Tennessee Valley Authority, 1101 Market Street, Chattanooga, TN 37402

CNL-17-147

Clinch River Nuclear Site
NRC Docket No. 52-047

Subject: Clarification of Supplementation Information Associated with Hydrologic Engineering in Support of the Clinch River Nuclear Site Early Site Permit Application

Figure 2.4.3-17 (Sheet 3 of 8). Unit Hydrographs, Sub-basins 26, 27, 34 & 35

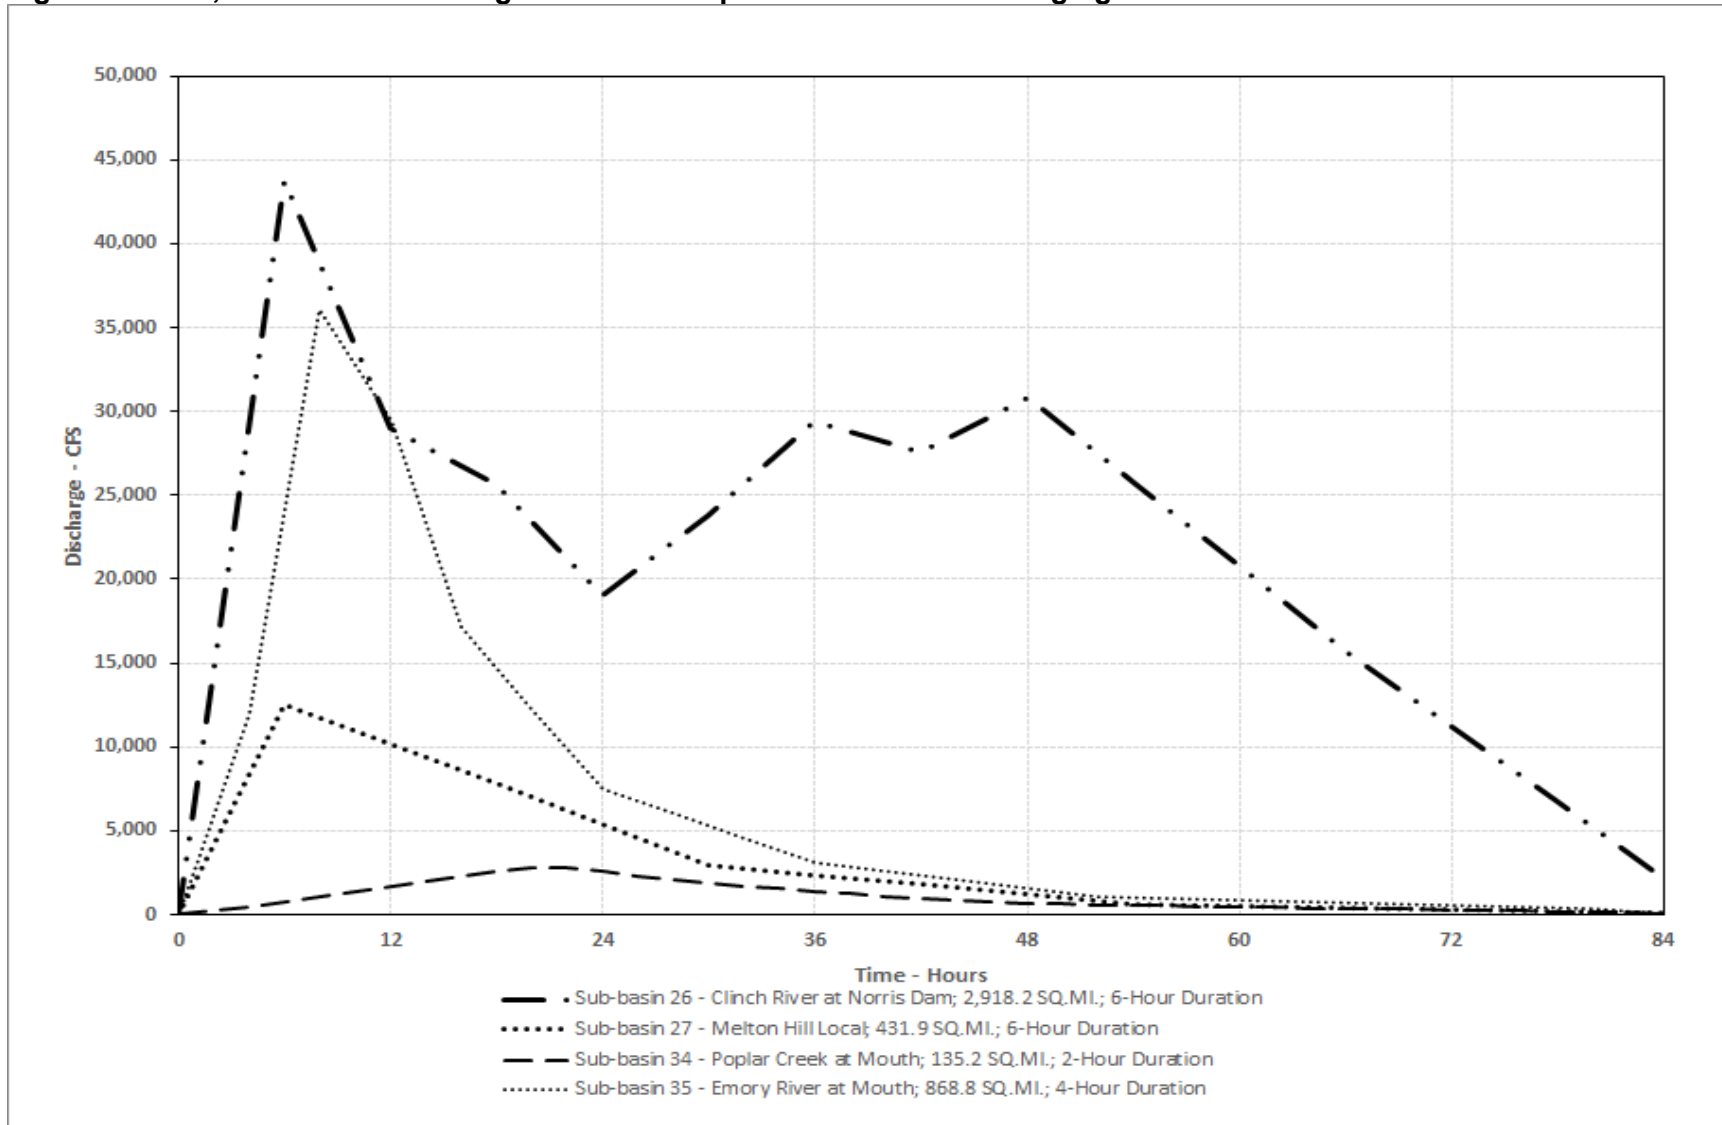
In SSAR Figure 2.4.3-17 Sheet 3 of 8, the sub-basin 14 and 15 Cherokee Local unit hydrograph was inadvertently inserted for the sub-basin 27 Melton Hill Local unit hydrograph. SSAR Figure 2.4.3-17 Sheet 3 of 8 is revised to insert the corrected sub-basin 27 unit hydrograph. SSAR Figure 2.4.3-17 Sheet 3 of 8 is being revised and the updated figure is in the SSAR markup provided in Attachment 2 of this Enclosure. The SSAR markup will be incorporated in a future revision of the ESPA.

Figure 2.4.3-17, Sheet 3 of 8 is being revised and replaced with the following figure:
